UNITED STATES PATENT AND TRADEMARK OFFICE

APPLICATION NO.	FILING DATE	FIRST NAMED INVENTOR	ATTORNEY DOCKET NO.	CONFIRMATION NO.
10/700,490	11/05/2003	Paul Stone	3229/4	6284

Office Action Summary	Application No. 10/700,490	Applicant(s) STONE ET AL.	
	Examiner Debra Wolfe	Art Unit 3725

DETAILED ACTION

FIG: 1

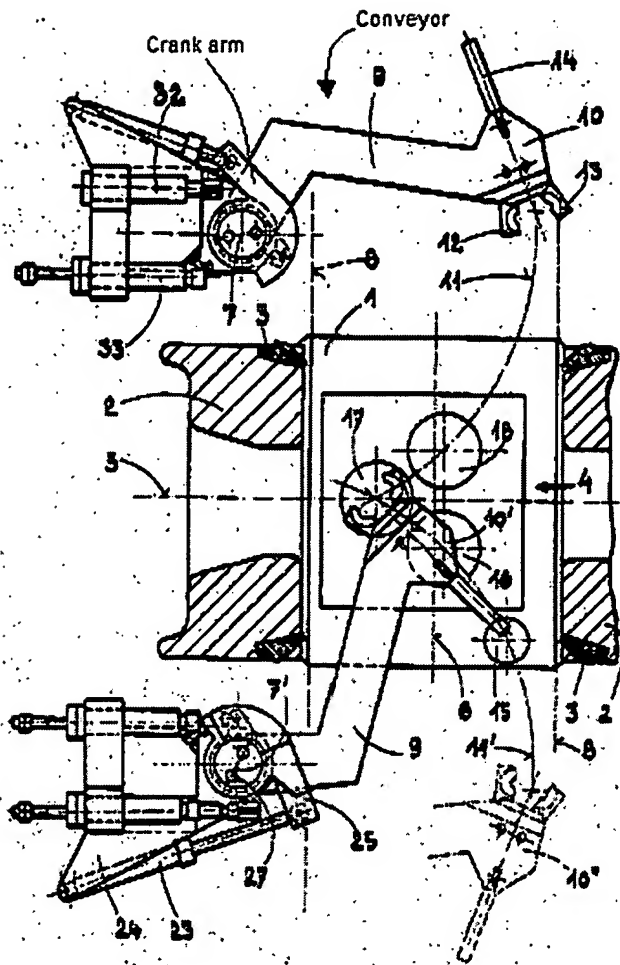
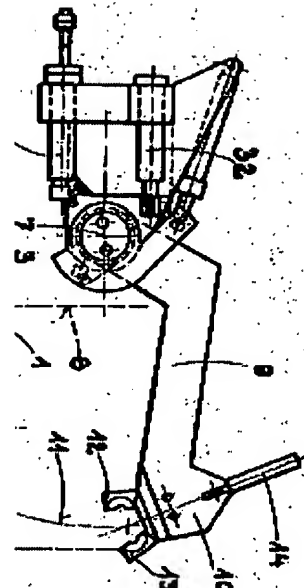
1. Claims 12-16 and 22 are rejected under 35 U.S.C. 103(a) as being unpatentable over Cvacho et al (U.S. Patent # 3,628,368) in view of Bachmann (U.S. Patent # 3,824,833) in further view of Nakamura (JP Patent # 5-177291) and Fuchs Jr (U.S. Patent # 4,644,775) and Takayama (U.S. Patent # 6,192,285 B1). Cvacho et al discloses a work piece positioning apparatus and machine having a conveyor (cup receiver 57) for precisely positioning a cup-shaped workpiece into position at a die (60) from a supply source. Cvacho et al also discloses a punch (55, See FIG 10) with a moving means comprising of a motor (34), a housing assembly (53) and intermediate wheels, linkages, and drive connections (See col. 2, line 59). Cvacho et al does not disclose a conveyor that is capable of loading and unloading a workpiece from the die station. However, Bachmann discloses a forging press having a conveyor (See FIG 1) to load and unload workpieces to or from a forging working space (4). The generally J-shaped conveyor (See FIG 1A) of Bachmann comprises of a first pivot assembly (pivot spindle 7), a movable robot arm (handling lever 9) with a crank arm (See FIG 1), and an end effector (grippers 10) and is actuated by a piston-cylinder system (23, See col. 5, line 56).

Therefore it would have been obvious to one of ordinary skill in the art at the time the invention was made to modify Cvacho et al with a conveyor which is capable of loading and unloading a workpiece from a supply source to a die station and then to a storage area as taught by Bachmann in order to effectively load and unload a workpiece in a timely and efficient manner.

FIG: 2

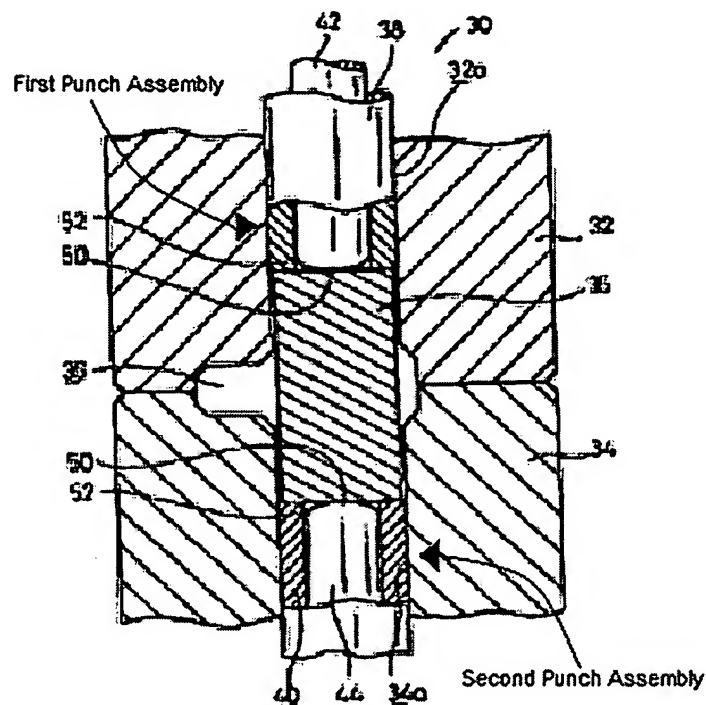
2. Cvacho et al does not disclose a first and second punch assembly having inner and outer punches. However, Nakamura discloses a closed forging device having a first and second punch assembly (See FIG 2) each comprising of an inner punch (42, 44) that is surrounded by the outer

punches (40) and is in sliding engagement therewith. Nakamura also shows in FIG 2 each inner (42, 44) and outer (40) punch share a common axis and the punch assemblies are in a confronting relationship to one another.

Although the apparatus of Cvacho et al only contains a single punch the complexity of the drawing was simple and two punches was not needed, however Nakamura teaches the use of multiple punch assemblies to form complex shapes. Therefore it would have been obvious to one of ordinary skill in the art at the time the invention was made to modify Cvacho et al with the multiple punch assemblies as taught in Nakamura in order to be capable of forging complex shapes at a single station.

FIG: 3

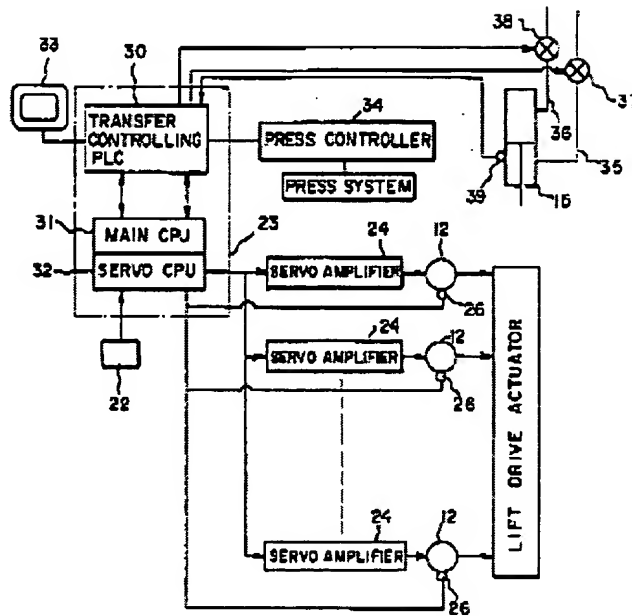
4. As stated in Fuchs Jr it is know in the art to use a control means, as disclosed by Takayama, for controlling the dies and conveyor of Cvacho et al. Takayama discloses a controller for work transfer systems having a programmable logic controller (transfer system controller 23) comprising of a transfer controlling PLC (30), a main CPU (31) and a servo CPU (32) for controlling the servo motor (12) of the feed bars (11) (See FIG 3 and col. 5, line 38).

Therefore it would have been obvious to one of ordinary skill in the art at the time the invention was made to modify Cvacho et al with a programmable logic controller and servo actuator for rotation of the robot arm as taught by Takayama in order to provide efficient movement of the punches and conveyor.

FIG: 4

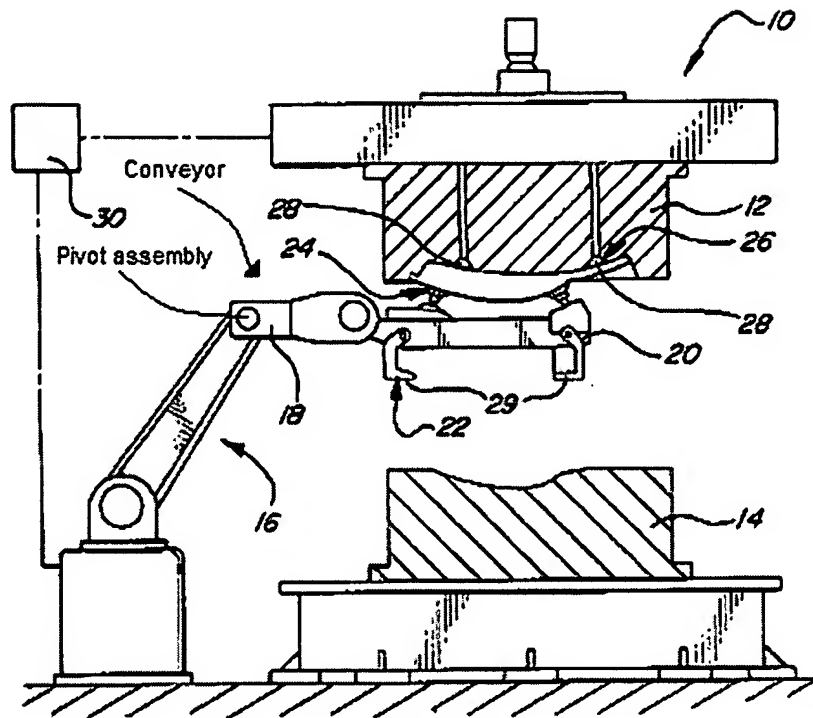
2. Bachmann (U.S. Patent # 3,824,833) discloses a forging press having a conveyor (See FIG 1) for conveying a forged product to and from dies and the working space (4). The conveyor (See FIG 1) comprises of a pivot assembly (pivot spindle 7), a movable robot arm (handling lever 9) with a crank arm (See FIG 1 above), and end effector (grippers 10) with two movable jaws (12, 13) and is actuated by a piston-cylinder system (23, See col. 5, line 56). Toeniskoetter (U.S. Patent # 6,125,683) discloses a closure panel hemming system having a conveyor (See FIG 4). The conveyor (See FIG 4) comprises of a pivot assembly (See FIG 4), a movable robot arm (18) with a crank arm (robot 16), an end effector (20) and first and second carrier elements (pivoting clamping fingers 29).

3. However the above cited prior art fails to disclose the first and second carrier elements whereby "said first carrier element fixed to said robot arm and said second carrier element pivotally connected to said first carrier element for rotation about a second axis and said first and said second carrier elements adapted to receive a work piece therebetween when in a closed position; said second of said carrier elements including a concave upper portion adapted to receive a forged product thereon when in a closed position and an outwardly extending finger; an unloading actuator for engaging said outwardly engaging finger as said robot arm rotates about said first axis to move said second carrier element into an unloading position to deliver the forged product to a storage area, and means for returning said second carrier element to its closed
